CHAPTER 343, HRS
Environmental Assessment (EA)/Determination
Finding of No Significant Impact

**2004-04-23 FONSI
HALEIWA SEAWALL RECONSTRUCTION**

**Final
Environmental Assessment and
Coastal Engineering Evaluation for
TMK: 5-9-03:24 Lot 8
(Paul M. Dold)**

Figure 14. Plan View of Seawall Construction.

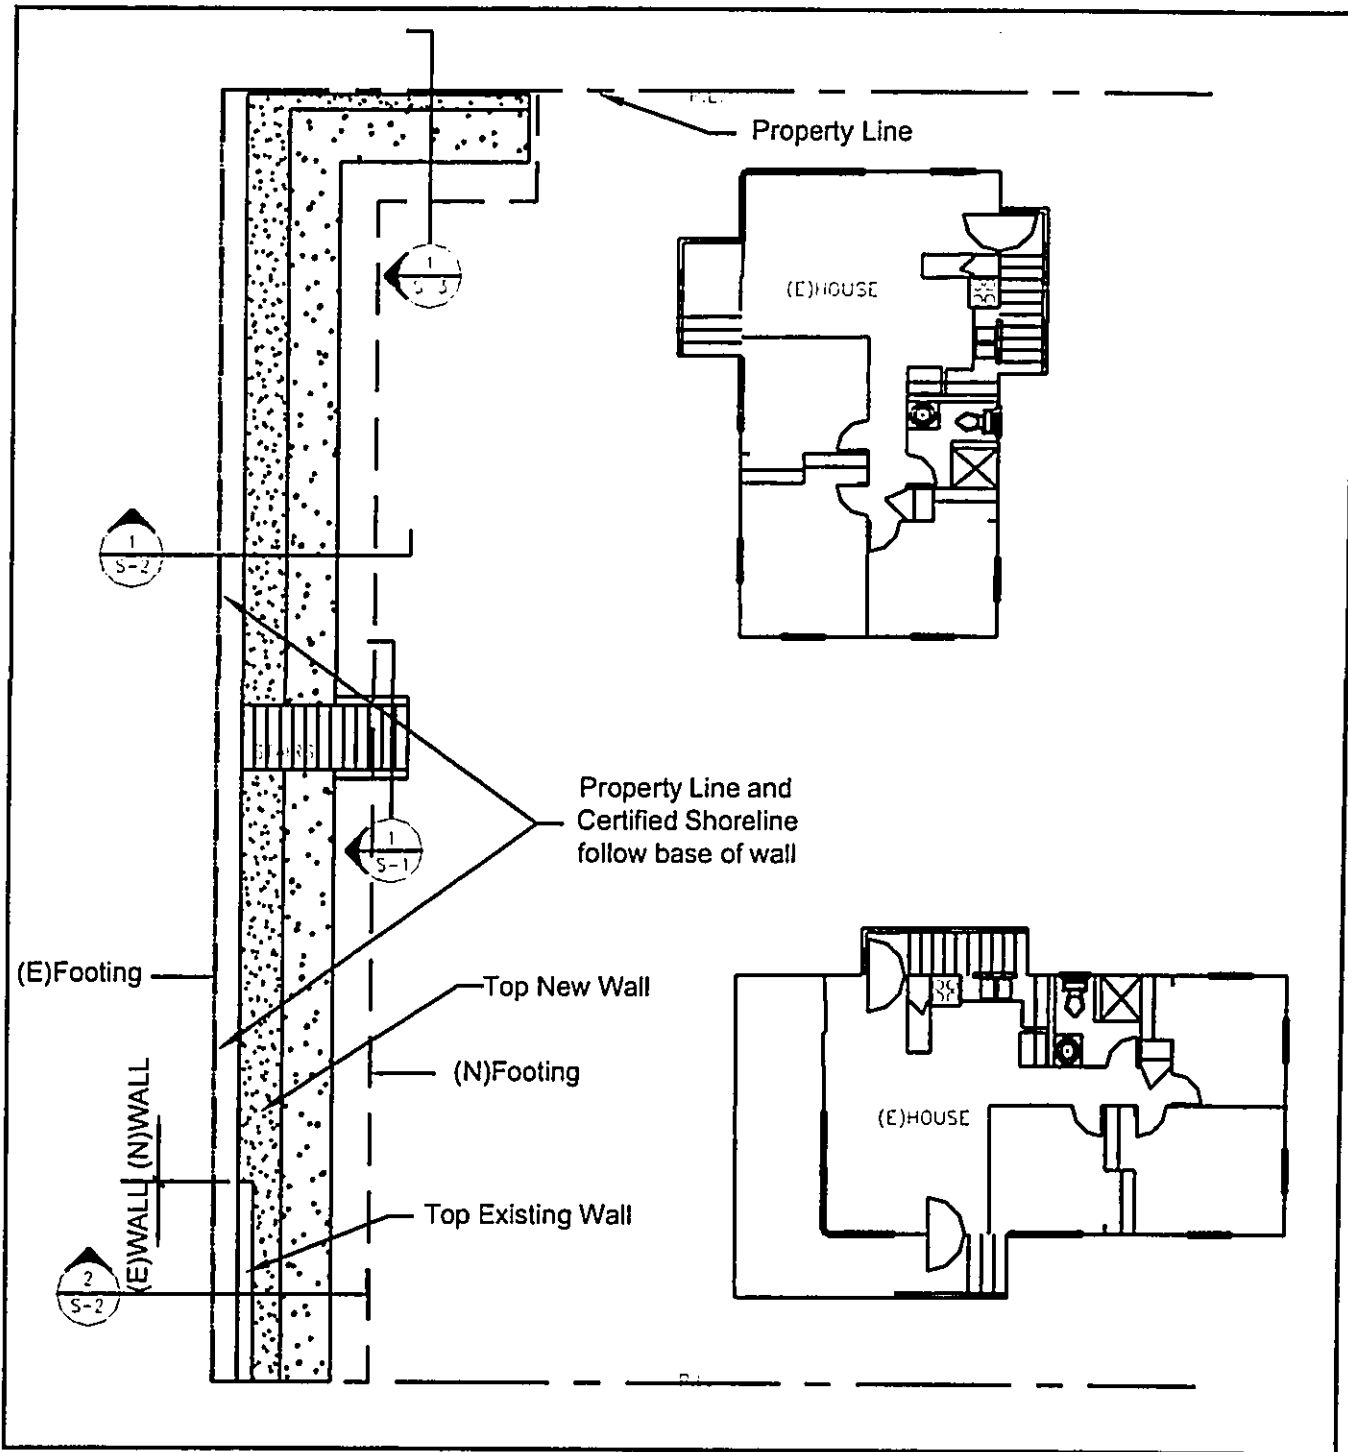
1. Figure 13 of the Draft EA should identify the shoreline and the rear property line. If possible, the base and top of the wall, existing and proposed, should be identified on this plan or on a separate plan view.

2. The configuration and orientation of the houses shown in Figure 13 of the Draft EA, as well as that of the full and half-size plans, differ from that of the shoreline survey. This discrepancy should be resolved in the Final EA.

3. The location of the existing and new and existing walls shown on the full and half size plans, the survey and Figure 13 in the Draft EA differ from each other. This discrepancy should be resolved in the Final EA.

1. Figure 13 in the draft has been amended as Figure 14 in the final EA. Shoreline, rear property line and top of wall (existing and proposed) have been identified. The extent of the footing at the base of the wall has also been identified on the figure.

2. Configuration and orientation of the houses in the figure have been modified to conform with the shoreline survey.
3. The locations of the existing and new walls have been resolved on the plans to conform with the location shown on the survey and in Figure 14 of the final EA.

Figure 15. Cross Section showing new wall construction

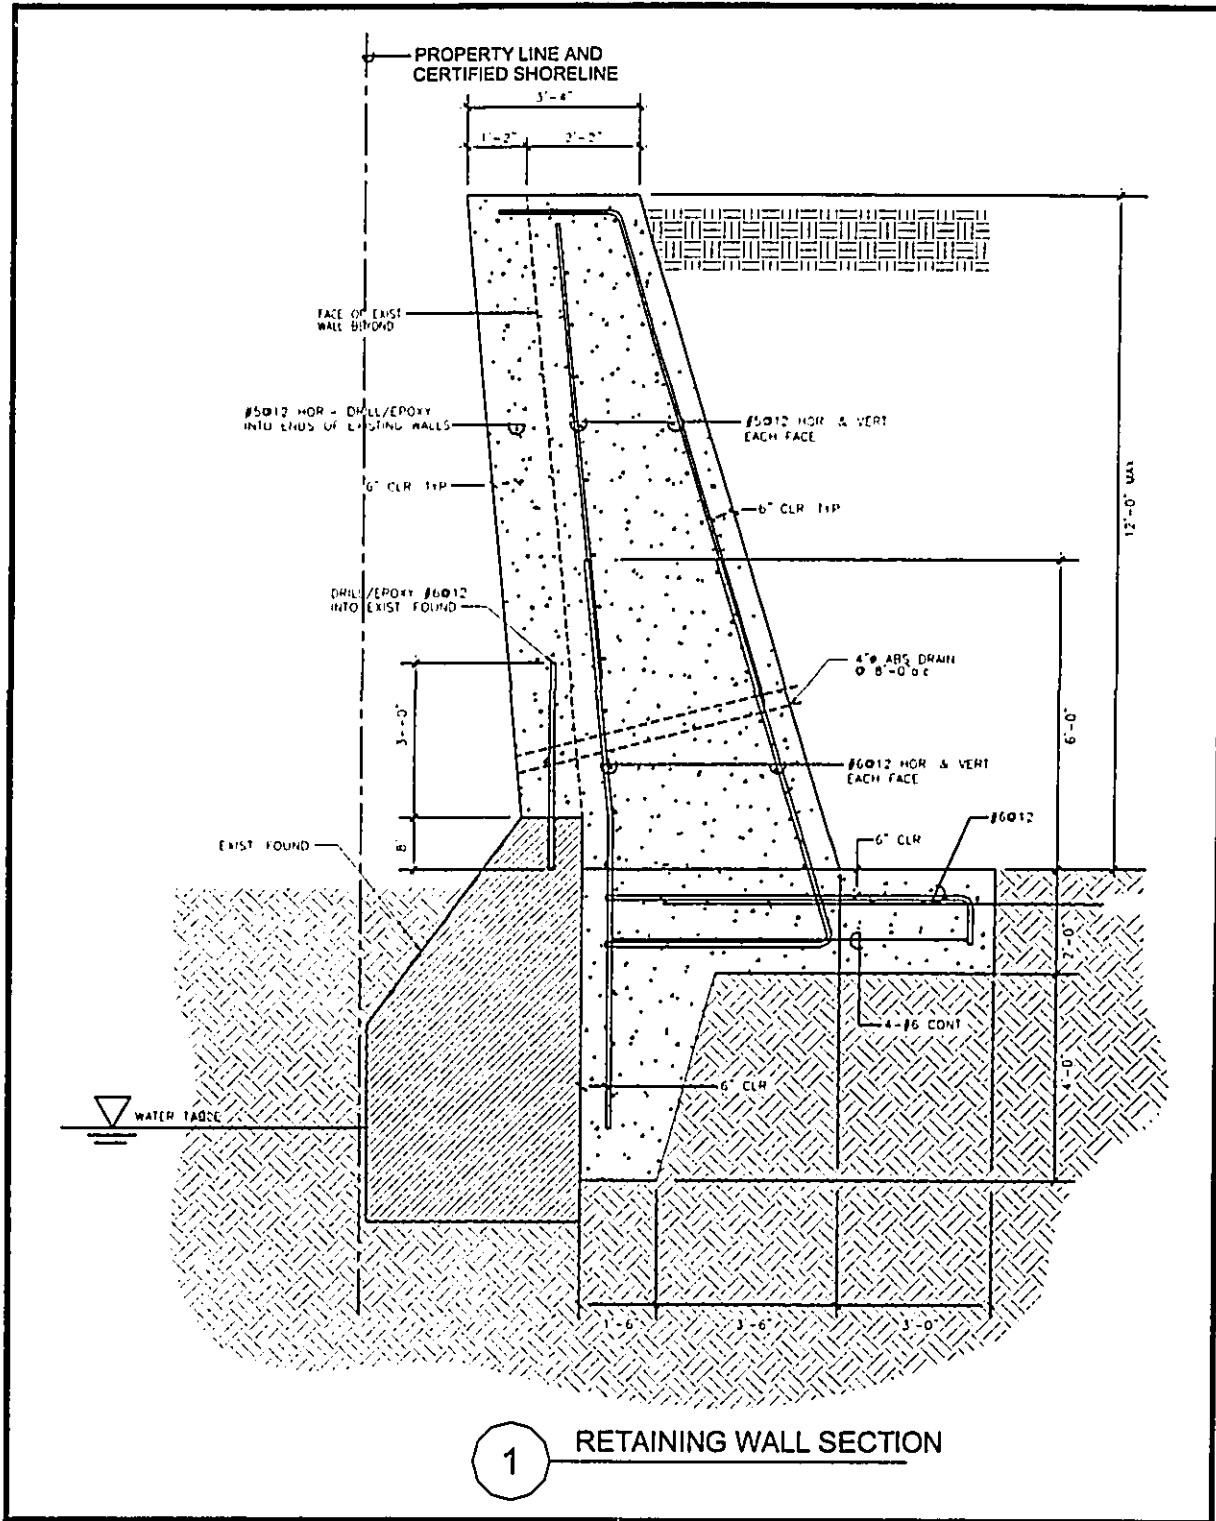
4. Will additional fill be placed landward of the proposed wall? If so, a description of the type and volume of the fill should be provided in the Final EA. Will weep holes be provided? If so, these should be shown on the plan.

4. Additional fill will be placed landward of the wall. A description of the fill material and quantity had been described in Section 6 of the final EA. Weep holes are provided for in the design of the new wall, and are shown in the plans and in Figure 15 of the final EA.

Figure 16. Cross Section showing repair of existing wall

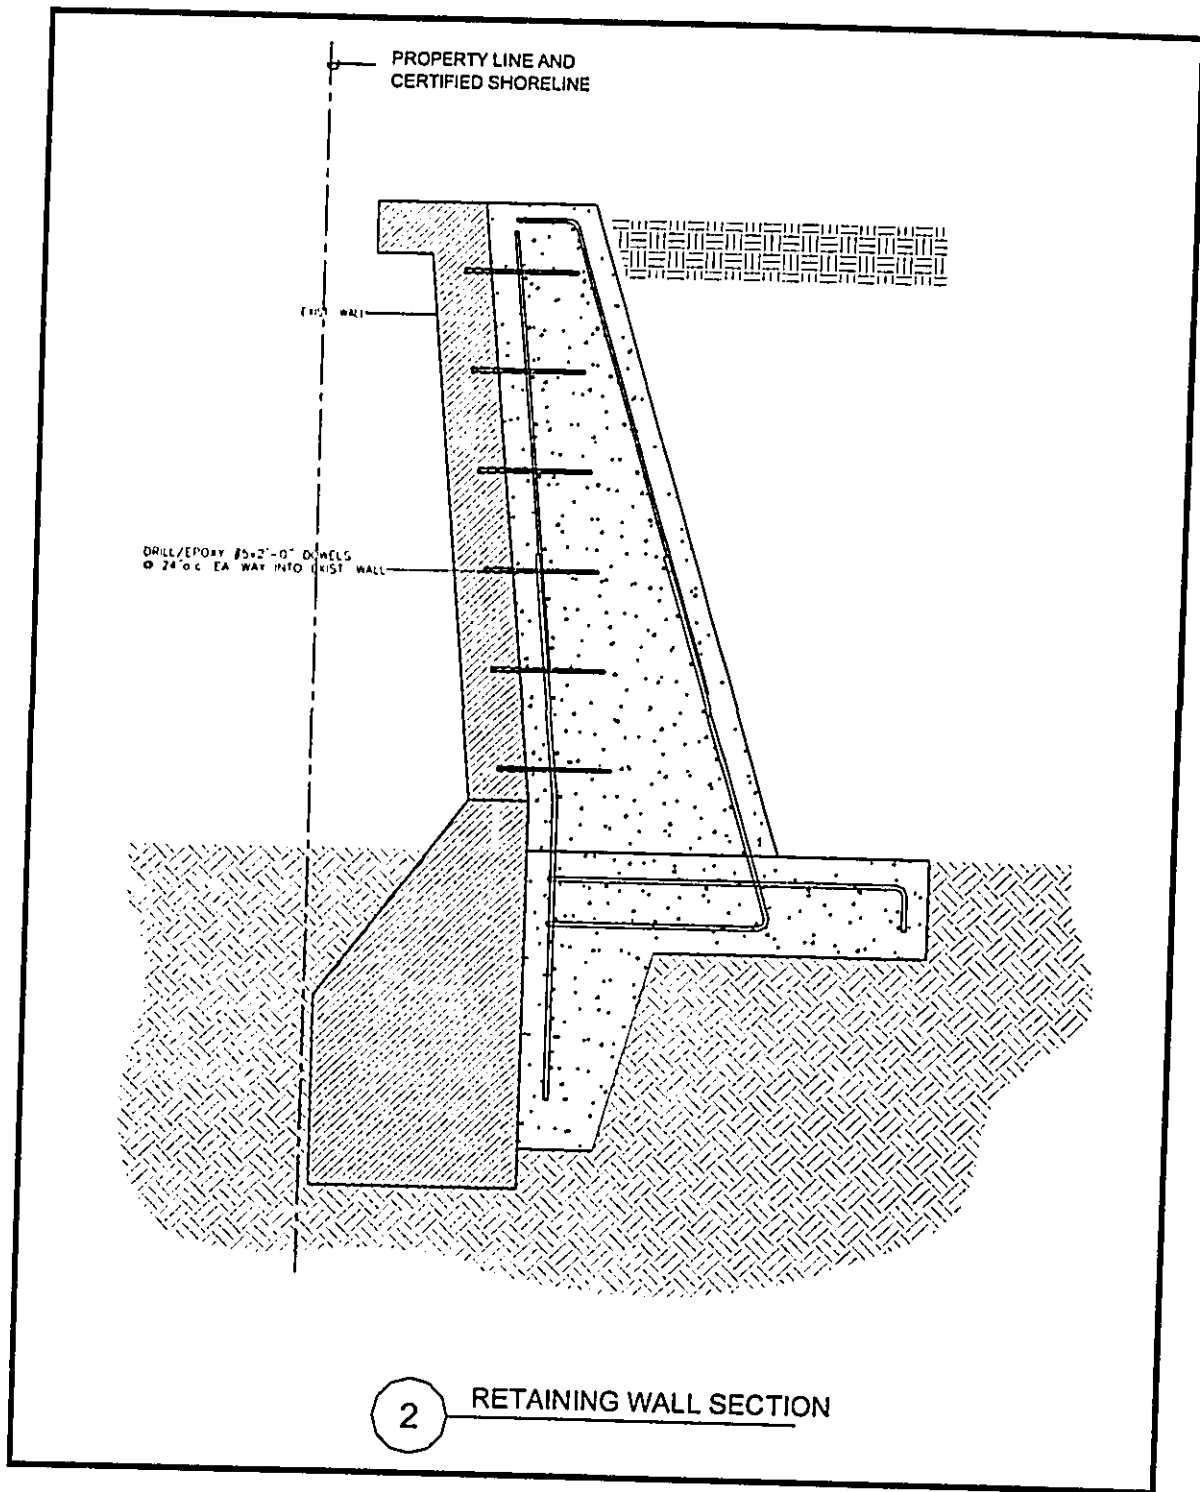
6. The dimensions of the proposed wall should be described in the text of the Final EA.
7. Construction methods, potential impacts, and proposed mitigation measures should be discussed in greater detail than that provided on page 28 of the Draft EA. Will the location of the construction activity be limited to the applicant's property, or will it extend into the area makai of the proposed seawall? The Final EA should give some examples of what mitigation measures will be undertaken to minimize adverse environmental impacts.

5. A copy of the certified shoreline survey has been included in the final EA as Figure 7.
6. The dimensions of the proposed wall are shown in Figures 14, 15, and 16, and further described in Section 6 of the final EA.
